**NOTICE OF A REGULAR MEETING
BONDURANT PLANNING AND ZONING COMMISSION
JULY 22, 2021**

6. Action Items
 - a. RESOLUTION NO. PZ-210722-15: Considering recommended approval of the Black Oak Farm Plat 1 Preliminary Plat (Unincorporated Polk County)

- c. RESOLUTION NO. PZ-210722-17: Considering recommended approval of the Dollar General site plan at 501 Hawthorne Crossing Drive SE.
 - d. PUBLIC HEARING - Request for rezoning from the Agricultural (A-1) District to the Planned Unit Development (R-5) District on property currently owned by Top Farms LLLP north of Park Side Plat 2 and adjacent to Highway 65; and request for Future Land Use Map amendment from Single-Family Residential to Multi-Family and Commercial on areas as shown on the PUD Conceptual Plan.

- f. RESOLUTION NO. PZ-210722-19: Considering recommended approval of the RAMMS Construction site plan at 1120 2nd Street NE.
7. Reports / Comments and appropriate action thereon:

Site Plan

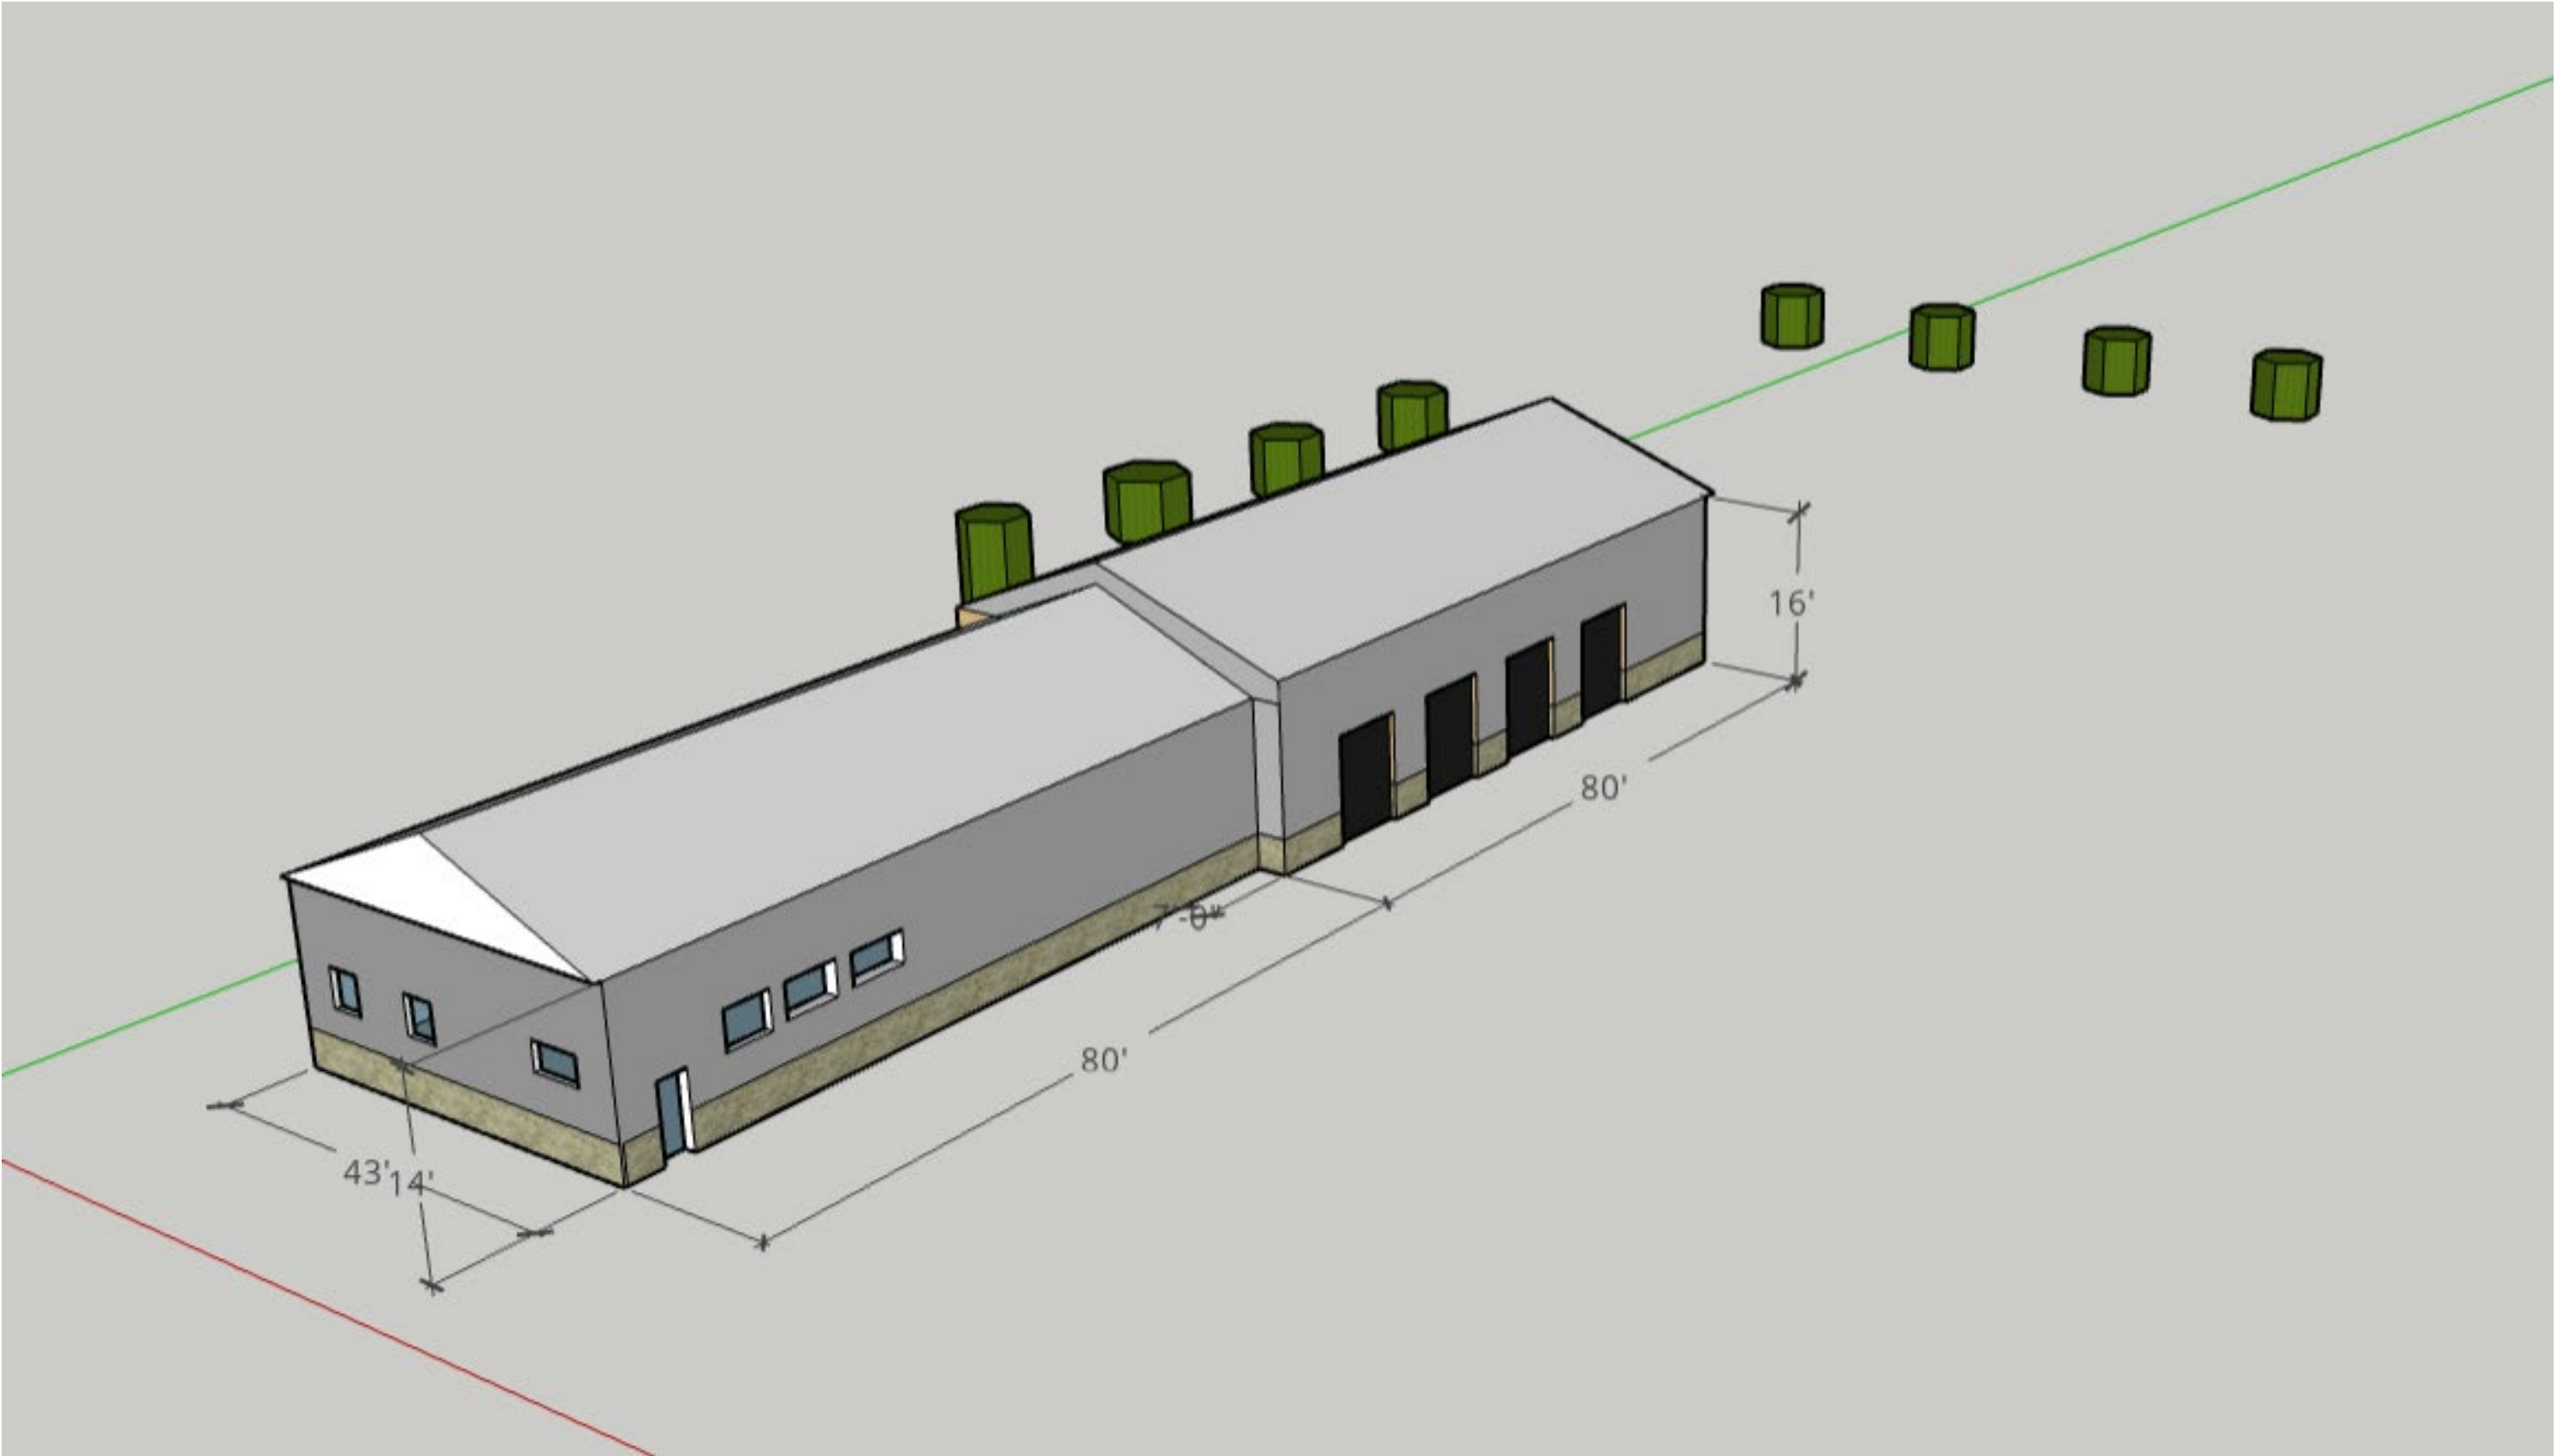
- Bob Veenstra noted that no stormwater management report is required for this addition, as the addition will not increase the site's impervious SF. The addition area is currently gravel.
- This site is not located within a floodplain.
- This site is not located within the City's Stream Buffer Ordinance area.
- The site plan shows no new utility connections into the building.

- As part of the variance approval, the Board of Adjustment required that a row of evergreen trees be planted along the north side of the building addition area. The submitted site plan shows this.

1. That should any City Code comments/concerns be relayed by City Engineering, Public Works, or the Fire Department, the site plan shall be updated to accommodate such feedback.
